NOTE TO NEW COUNCILLORS RE 351 BARRENJOEY RD DA BREACHES TO NEWPORT MASTERPLAN AND SIMILAR ISSUES.

Following review of the Assessment Report provided to the NBLPP which recommends approval of the DA we have noted three major issues that show a disrespect for the Newport Masterplan. The breaches outlined in points 1 to 3 are the reasons that the density of the proposed building is excessive. By allowing these breaches it sets a huge precedent and a continuing undermining of the Newport Masterplan.

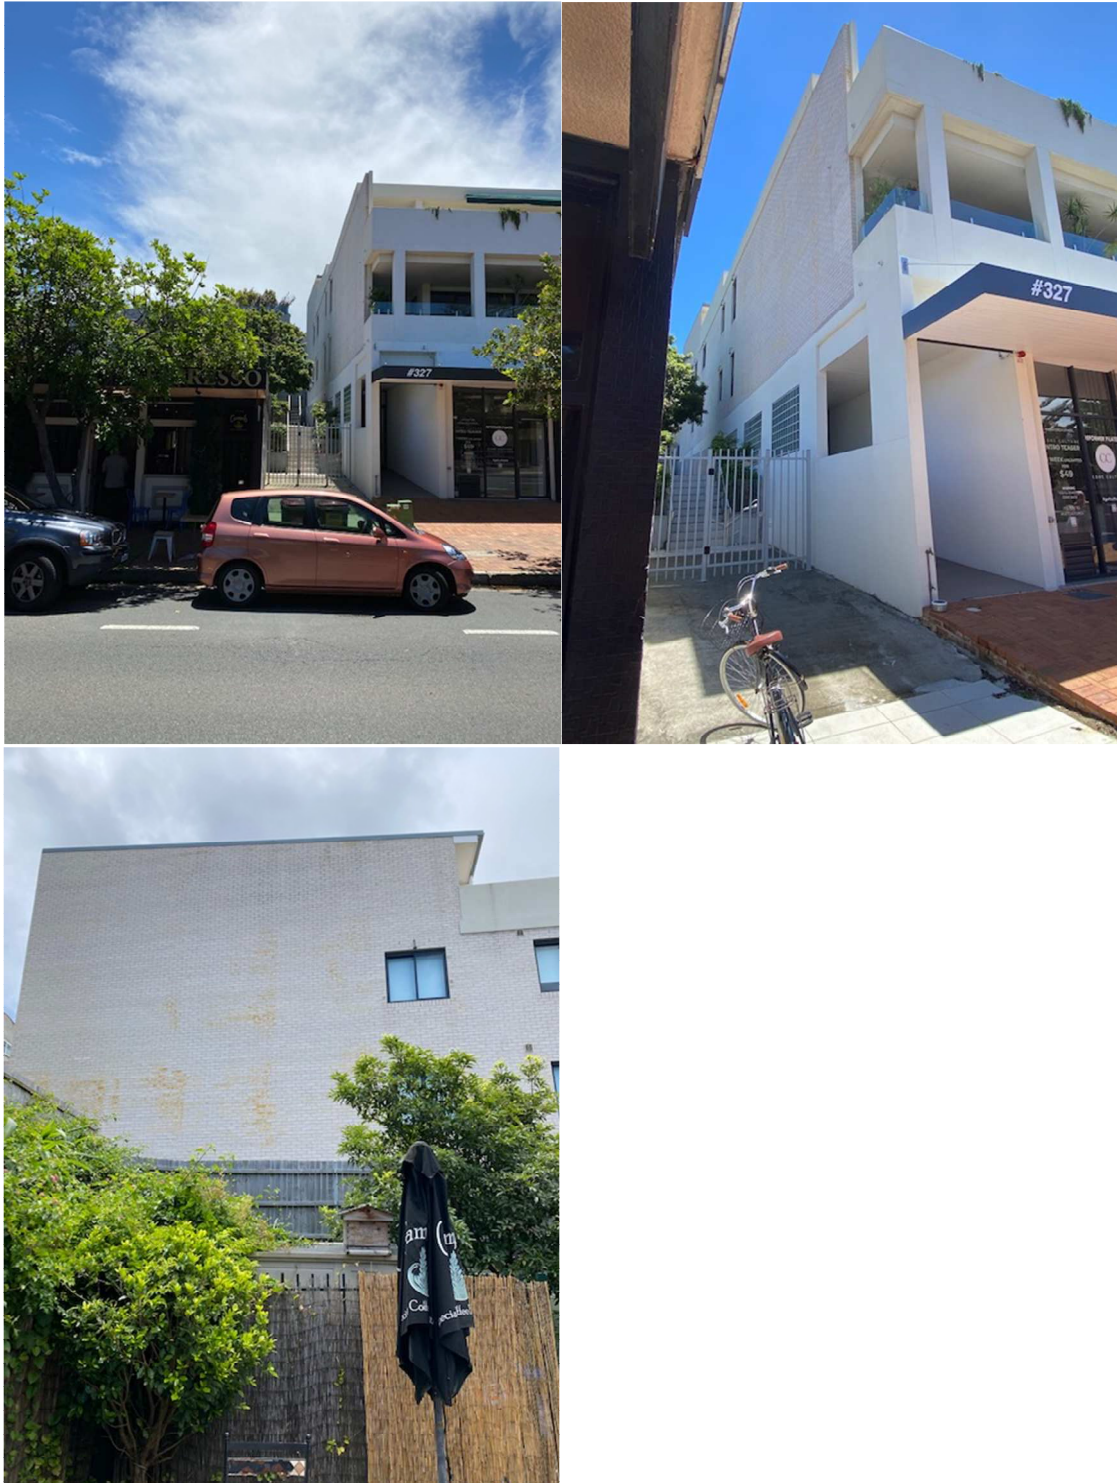
1. The second level (third storey) addressing Barrenjoey Road continues to ignore the DCP Newport Masterplan 5.5.2 to incorporate the required minimum 3m. setback from the common boundary again with adverse visual impact, particularly when viewing the exposed side blank wall from Barrenjoey road. This breach does not appear to have been addressed satisfactorily in the Assessment Report under 'Noncompliance with upper floor side setbacks...'. This breach is likely to remain very prominent for years to come as the adjoining plaza shops are in multiple ownerships and unlikely to be redeveloped soon. Noncompliance with this requirement of the DCP results in greater building density as well as a lost opportunity for better amenity (sunlight and seabreezes) along the desirable north-eastern boundary. The stated outcomes of the Newport Masterplan include that new developments are of two storeys visually and this setback is critical to this outcome. We attach three photos of a non-complying development on Barrenjoey Road with a similar breach that will now become a permanent blot on the visual village feel plus three photos of two complying developments where the setbacks have been incorporated in accordance with the NMP.

Re Point 1. Pictures of Non-complying set-back (next door to Zubi café)

Re Point 1. Pictures of complying development set-backs
